# PARTS & SERVICE NEWS

REF NO.	AT02032
DATE	Mar. 15, 2002

**SUBJECT:** IMPROVEMENT OF INTERFERENCE OF HYDRAULIC PUMP AND TRANSMISSION TRUNNION ON HD325-6

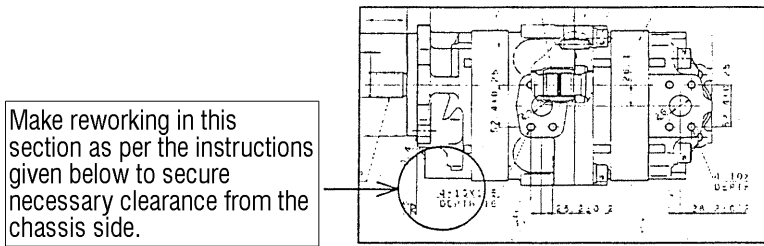
The possibility of occurrence of the above failure owes to the incorrect assumption that the pump mounting bracket was interchangeable when the shape of the bracket was changed to improve the aluminum casting process (to improve the flow of the molten metal) for the pump mounting bracket without conducting sufficient installation tests to the chassis.

Since there is no problem in the strength of the pump mounting bracket, make reworking of the bracket at the interfering section.

4. Modification procedure

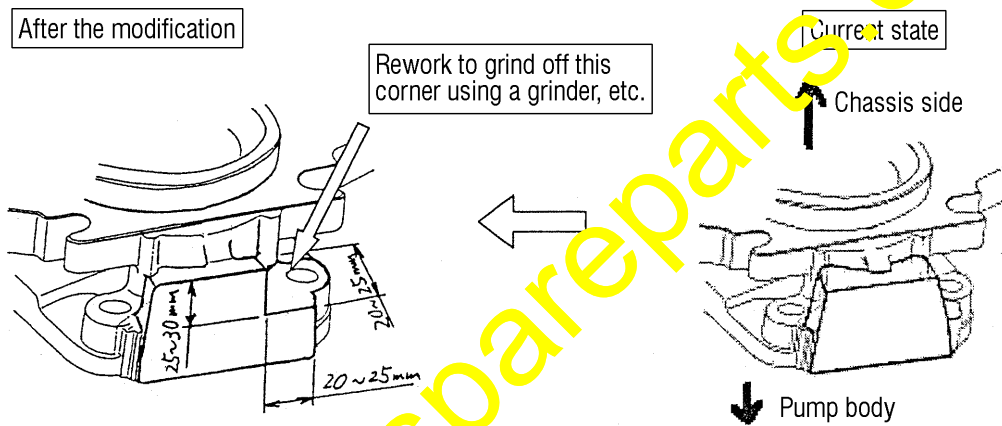
The shape of the pump mounting bracket is to be changed.

- (1) If interference occurs when replacing the pump or when reinstalling the pump after removal, make the reworking as per the instructions given in the drawing below
- (2) When removing and reinstalling the pump for this modification, be sure to follow the instructions being given in the Shop Manual and pay attention to the working safety.
